Ref: BHE/PW/PUR/NTPRT-750MT-CRH/2172/Corg-01

**Sub: Corrigendum-01:** Clarification & Drawings w.r.t. Technical Conditions of Contract (TCC) and extension of due date of tender submission.

**Job: Tender Specification No: BHE/PW/PUR/NTPRT-750MT-CRH/2172** for Providing Services of suitable Heavy Lift High Reach (HLHR) Crawler Crane of lifting capacity 750 MT & above for construction work at 3x800 MW PVUNL Patratu, Post –PTPS Ramgarh, Jharkhand.

TITLE: SILENCER SUPPORT ARRGT. FOR SEPARATOR SV  
DRAWING NO: 0-00-047-16291  
REV: 00

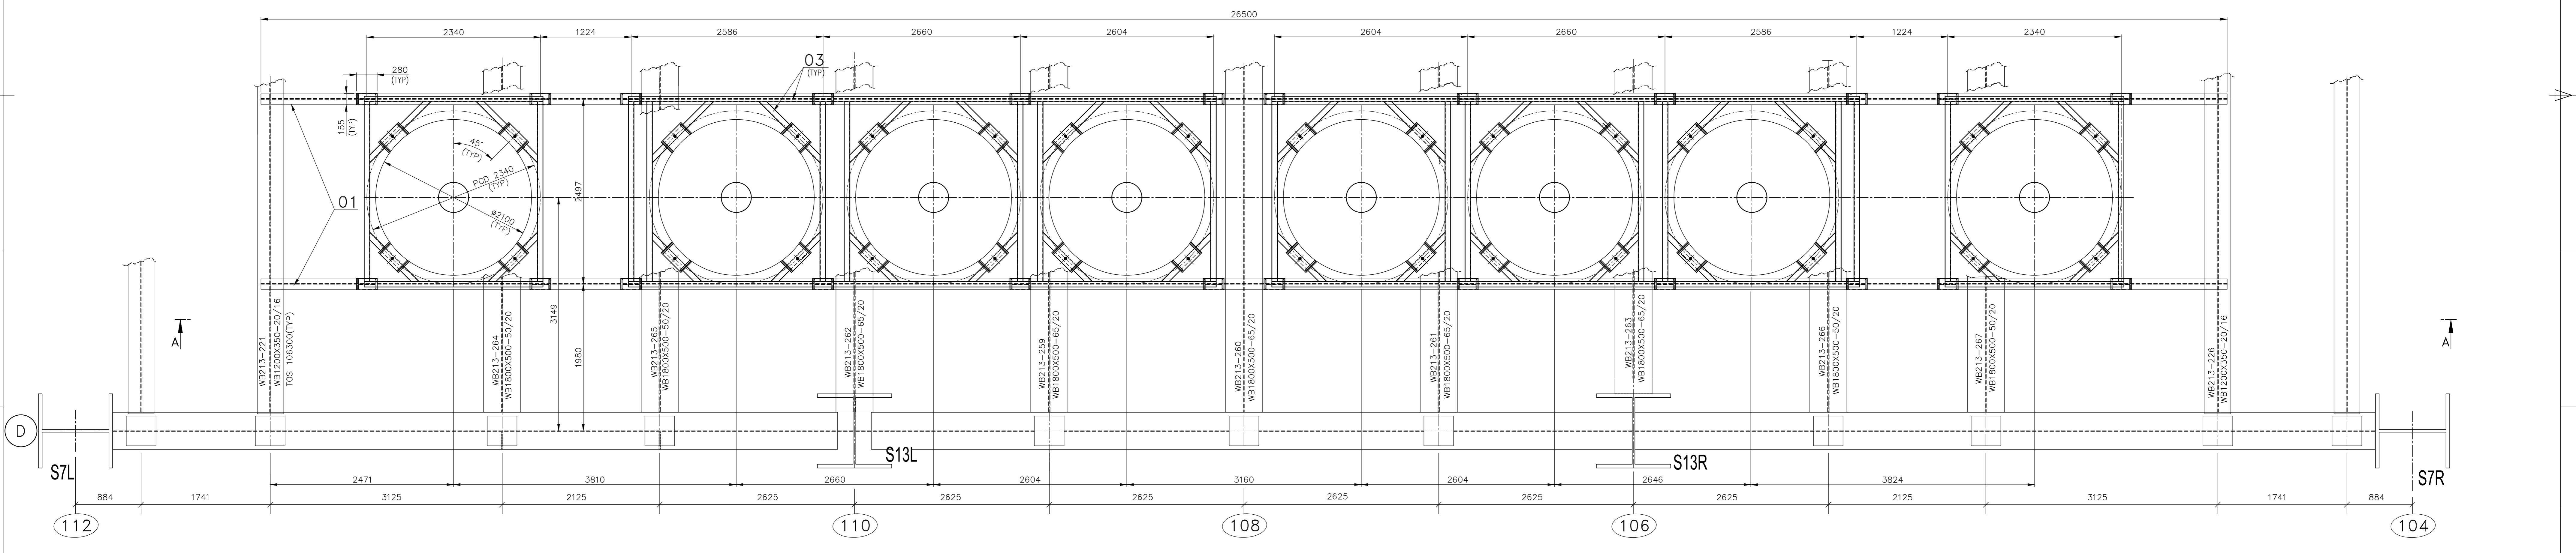
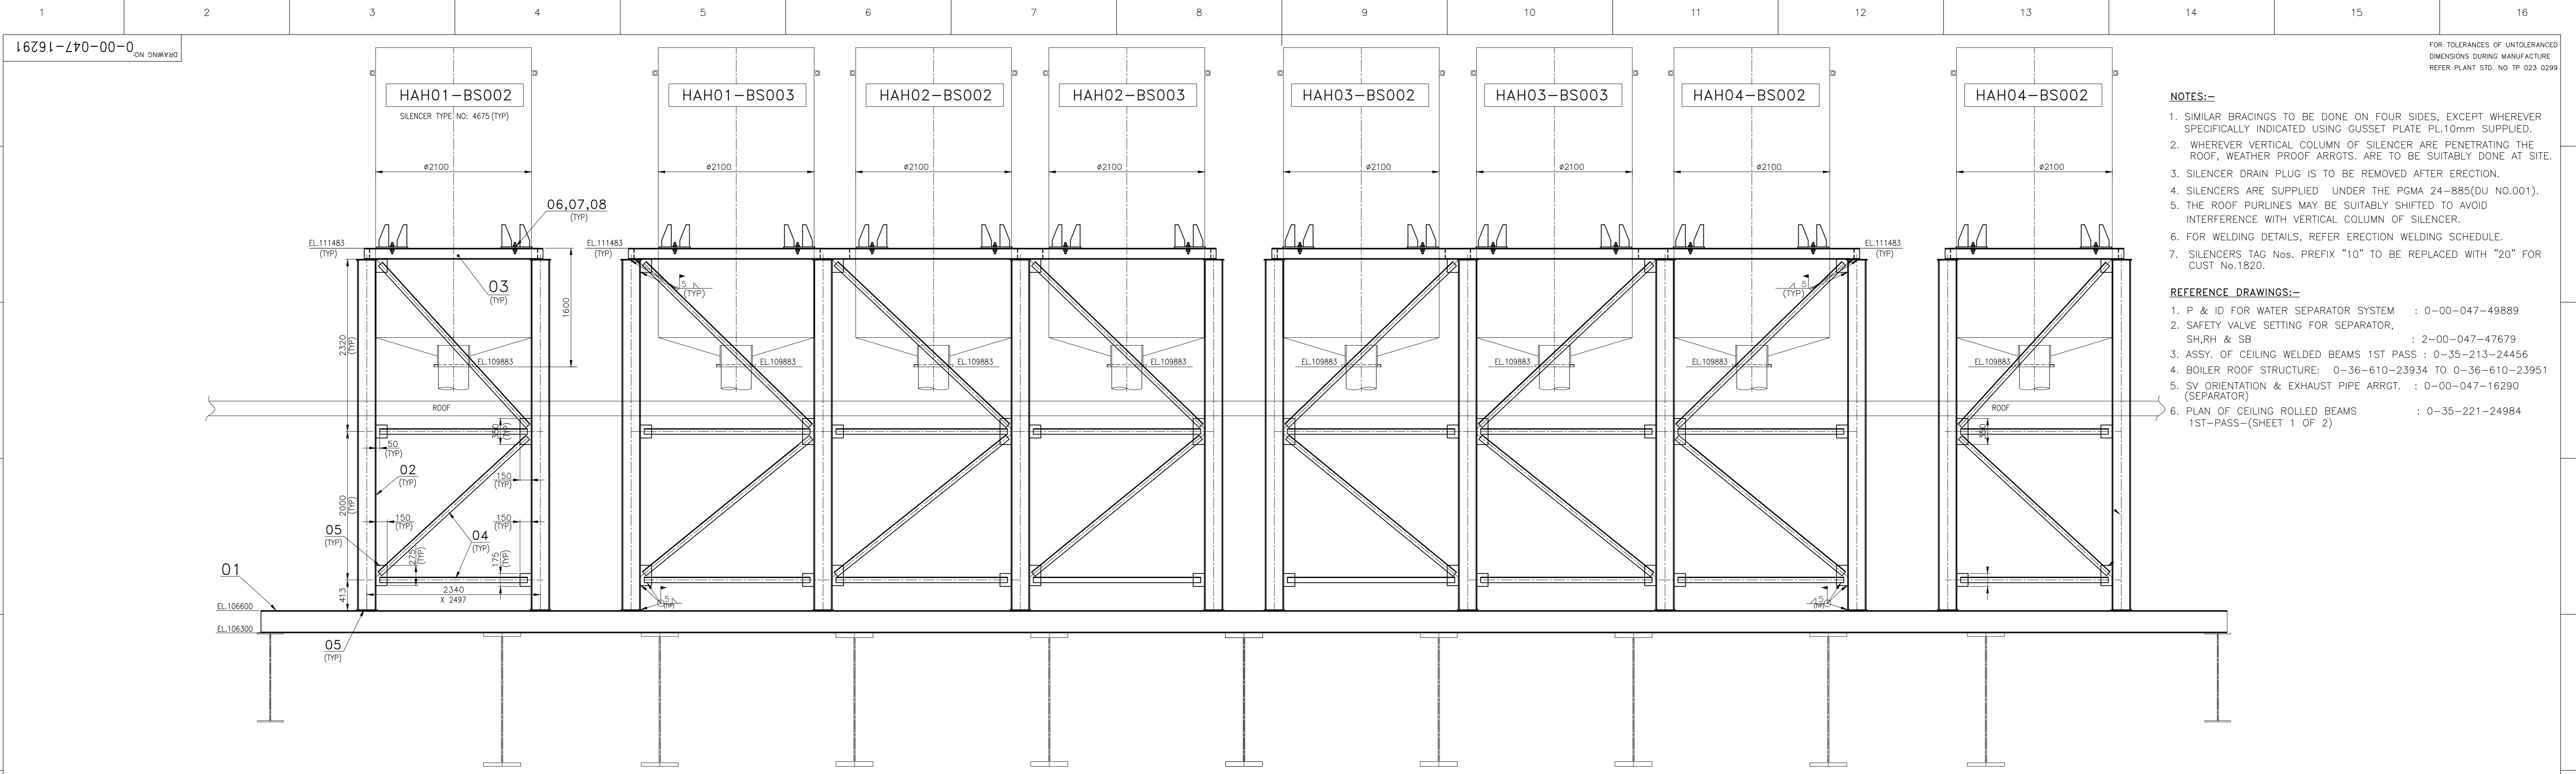
1. **Query:** Plot plan and Sequence of Equipment erection are required to ensure the space availability and equipment selection. Also, to elaborate with final placing position, particularly for silencer.

**Silencer:** A reference schematic CAD drawing is attached for silencer elevation. The exact drawings for silencer is not available at this moment. 02 nos. reference drawings for Silencer arrangement has been attached for reference purpose only. The actual drawings may vary.
